Design Review Board Case # 20-0002
Block 32 – Carlyle Plaza II / Carlyle Park Towers

Application	General Data	
Project Name: Block 32 – Carlyle Plaza II / Carlyle Park Towers Location: Block 32 – Eisenhower East Applicant: Carlyle Plaza, LLC c/o McGuireWoods LLP	DRB Date:	October 22, 2020
	Site Area:	Block 32 – Eisenhower East
	Zone:	CDD #11
	Proposed Use:	Residential, Retail, Parking, and Open Space
	Net Floor Area:	1,387,170 square feet (entire Block 32 development)
Purpose of Application: Conceptual review of the height, scale and massing for two tower buildings within Block 32 of the Eisenhower East area.		
Staff Reviewers: Robert M. Kerns, AICP robert.kerns@alexandriava.gov Thomas H. Canfield, AIA tom.canfield@alexandriava.gov Nathan Imm nathan.imm@alexandriava.gov Anna Franco anna.franco@alexandriava.gov

Block 32 – DRB Concept Review

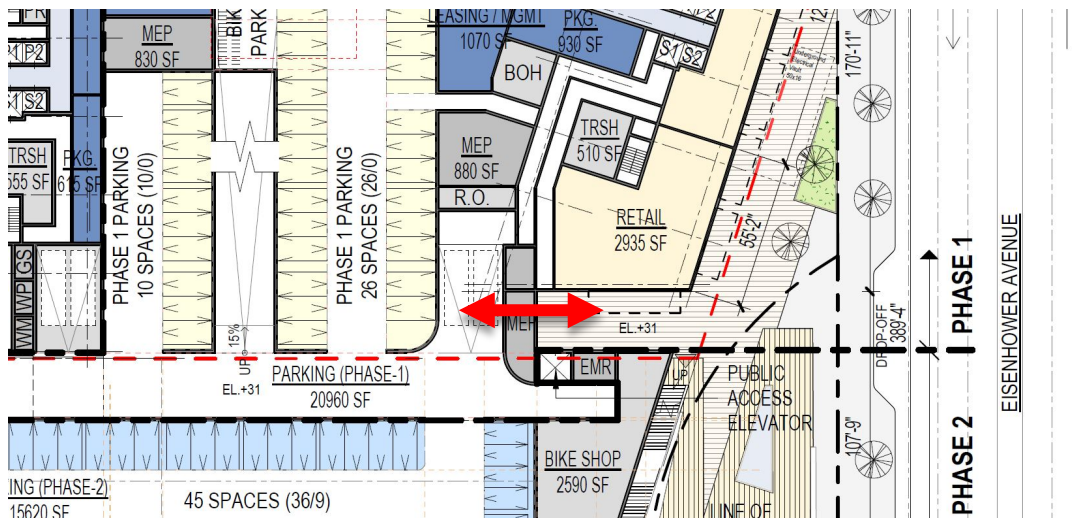
- Provide the gross floor area and net floor area for Phase 1 on page 2 “Zoning Tabulation”.
- Provide enhanced, direct access from ground floor level of the parking garage to the ground floor plaza for improved retail access. See diagram below.
